Cycle Enfield - Section 4

A105 Lodge Drive to Osbourne Road

Stage 2 Road Safety Audit

Ref: 2759.03.04/032/A105/BOR/2016

GENERAL ARRANGEMENT SHEET 6 OF 47

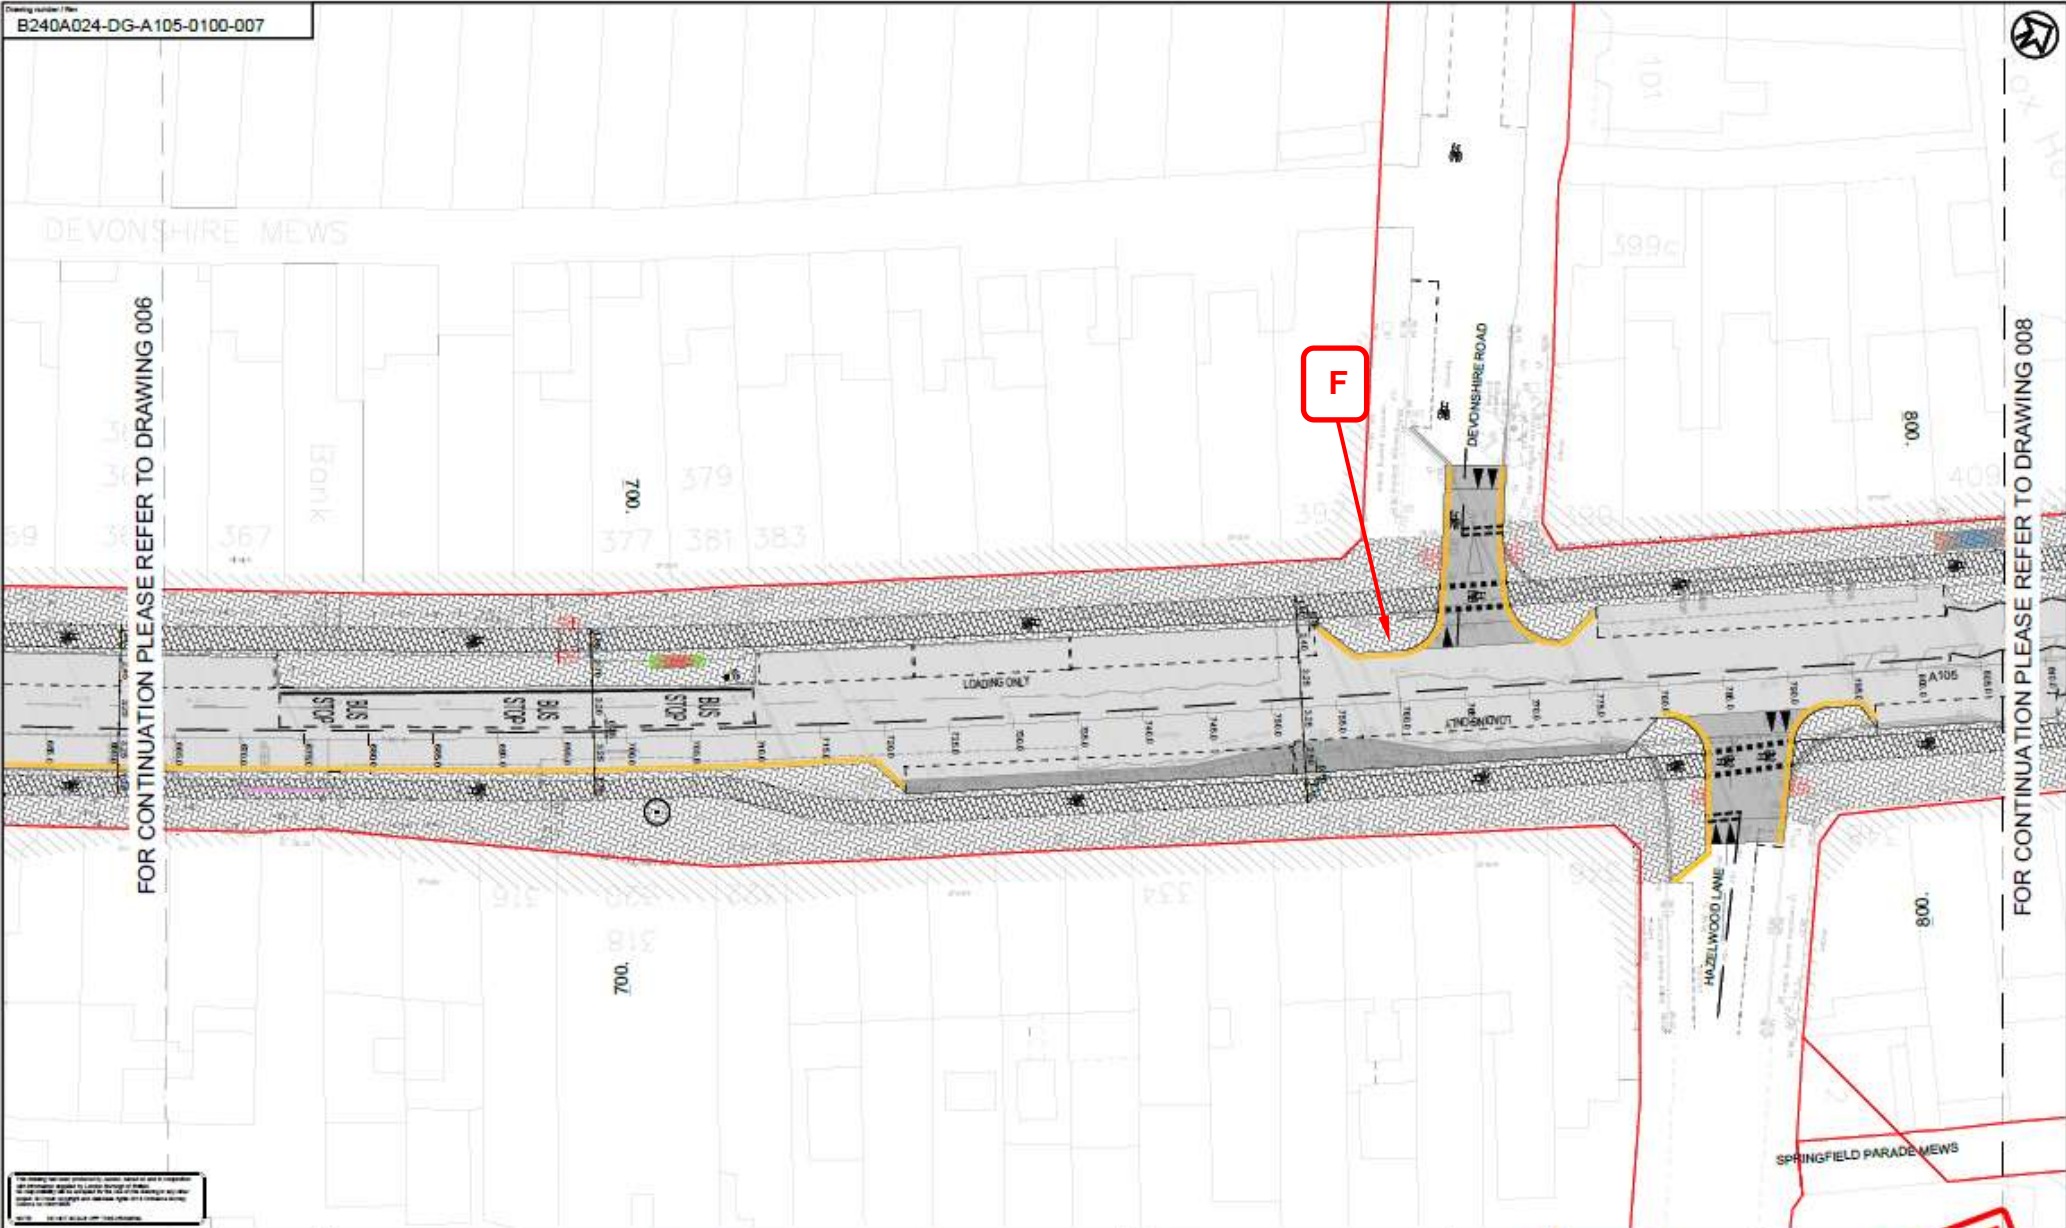
Location: A – A105 Green Lanes near junction with Lodge Drive

Summary: Proposed footway loading bay may result in an increased potential for collisions with cyclists

The proposals include a footway loading bay within this area. The Audit Team are concerned that vehicles entering / exiting this bay may:

- Over-run the cycle track as they try to align themselves within the loading bay,
- Not have sufficient visibility of cyclists in the cycle tracks due to the angle of approach / entry and cyclists being in a potential blind spot,
- Result in dooring of cyclists in the cycle tracks.

Location: D – A105 Green Lanes junction with Lodge Drive

Summary: Proposed road markings may lead to an increased potential for kerb strikes as southbound vehicles reach the southern side of this junction

The Audit Team are concerned that the proposed give-way markings may increase the potential for southbound drivers to take alignment guidance from these markings and collide with the kerb buildout which protrudes significantly on the southern side of the junction. If drivers collide with the kerb build-out then vehicles occupants may be injured or a rider of a two wheeled vehicle could be dismounted. Additionally, if motorists notice the kerb build-out in close proximity late then evasive action may result in loss of control and / or collisions with oncoming vehicles.

Location: 1 – A105 Green Lanes footway on north-eastern corner of junction with Lodge Drive

The traffic signal pole occupies part of the tactile paving area and is set back approximately a metre and a half from the edge of the kerb. This provision may make it difficult for a visually impaired user to find the push button unit.

It is recommended to provide an additional traffic signal pole / push button unit kerbside; this may also require alterations to the alignment of the cycle track and may require relocation of the proposed traffic signal pole to ensure the layout is clear and appropriate for all users.

Location: 2 – A105 Green Lanes footway on western footway at junction with Lodge Drive

The proposed cycle track at this location may result in the area between the cycle track and the carriageway not being fully utilised by pedestrians due to the segregation effect that the cycle track may have.

It may therefore be beneficial for pedestrian comfort to re-position the cycle track further east (closer to the kerb) so that it maximises the effective footway width (west of the track) for pedestrians.

Design Organisation Response	Accepted / Part Accepted / Rejected
A kerb with 125mm upstand will be provided at the edge of the parking to ensure that there is no over-run onto the cycle lane as they align themselves into the loading bay. Due to site constraints a minimum of 0.5m buffer has been provided throughout the scheme between the edge of cycle lane and the carriageway/parking or loading bays. This is considered wide enough to allow for opening doors and people to disembark from vehicles without causing an obstruction to the cycle lane.	
Client Organisation Comments	
Designer's response accepted

Design Organisation Response	Accepted / Part Accepted / Rejected
The line of sight for drivers should be taken from the zig zag markings, but the comment is noted and the give way markings will be amended.	
Client Organisation Comments	
Designer's response accepted.

The layout has since been amended as per TfL Signals and this is no longer an issue.

Design Organisation Response	Accepted / Part Accepted / Rejected
The alignment follows the original kerb line on approach to the crossing point. Whilst the comment is noted the current proposed position allows cyclists to enter the crossing area set back from the waiting point and then to continue past the loading bay without needing to make a change in direction.	
Client Organisation Comments	
Designer's response accepted.

Issue: [Redacted]
 Date: 02/08/24
 Drawing number: B240A024-DG-A105-0100-007

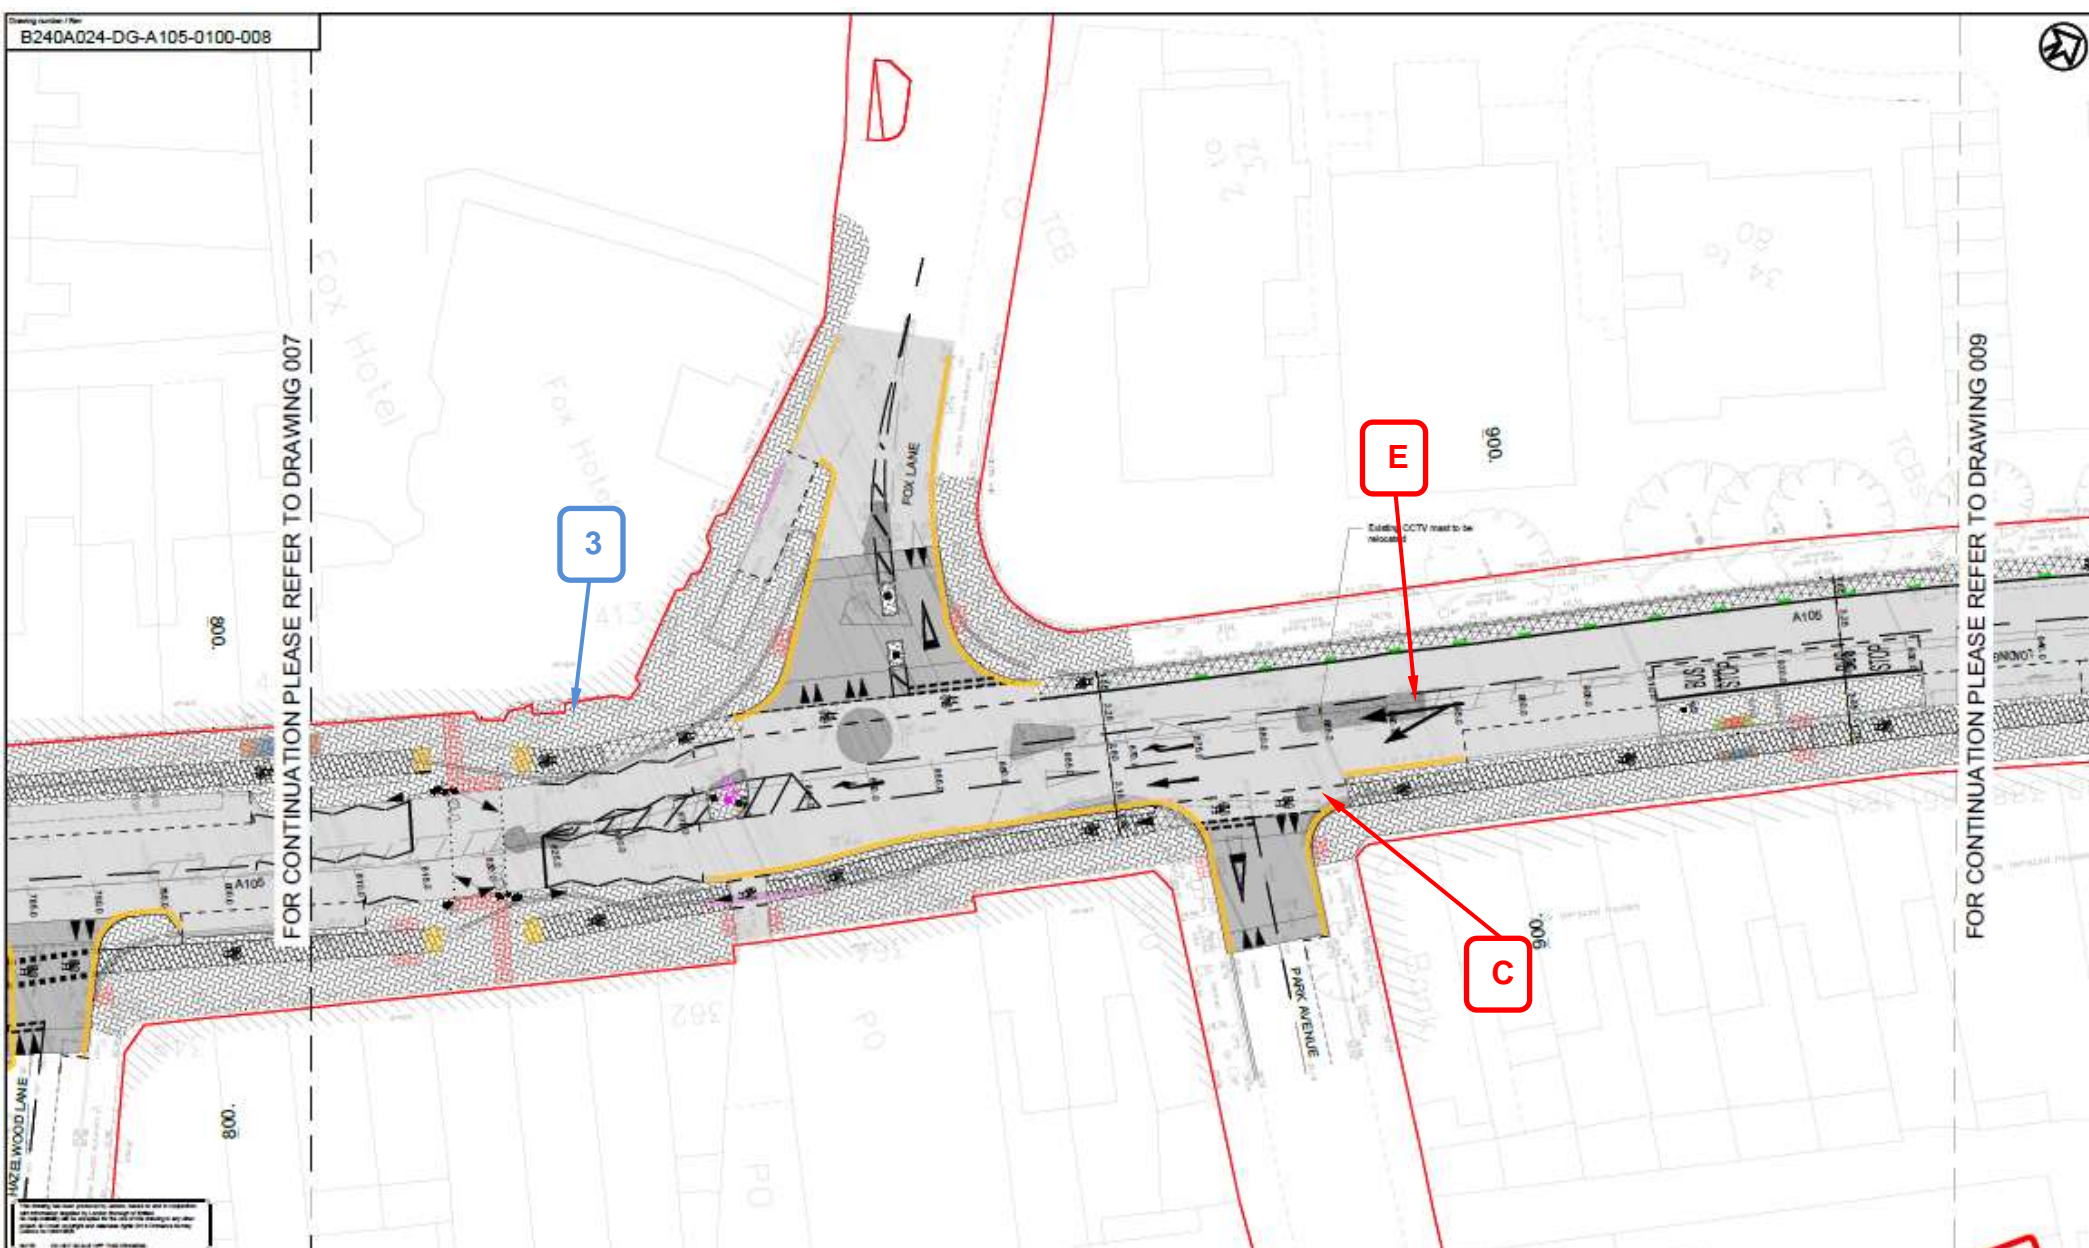
Location: E – A105 Green Lanes junction with Park Avenue

Summary: Proposed bifurcation arrow may be misleading and potentially result in shunt type or side swipe type collisions

The Audit Team are concerned that the proposed bifurcation arrow at this location may be misinterpreted as an indication that southbound motorists can continue ahead from what is effectively lane 2. Southbound motorists, particularly those passing a waiting bus, may increase the potential for southbound drivers to assume that the right turn lane is intended for ahead movements, particularly whilst the right turn lane is occupied and therefore the right turn arrows may be obscured. If motorists attempting to continue ahead inadvertently enter the right turn lane this may result in shunt type or side swipe type collisions as motorists may unexpectedly encounter a queue and either brake hard or make a late evasive manoeuvre to avoid the queue / continue to the nearside ahead lane.

Design Organisation Response	Accepted / Part Accepted / Rejected
The bifurcation arrow will be removed.	
Client Organisation Comments	
Designer's response accepted
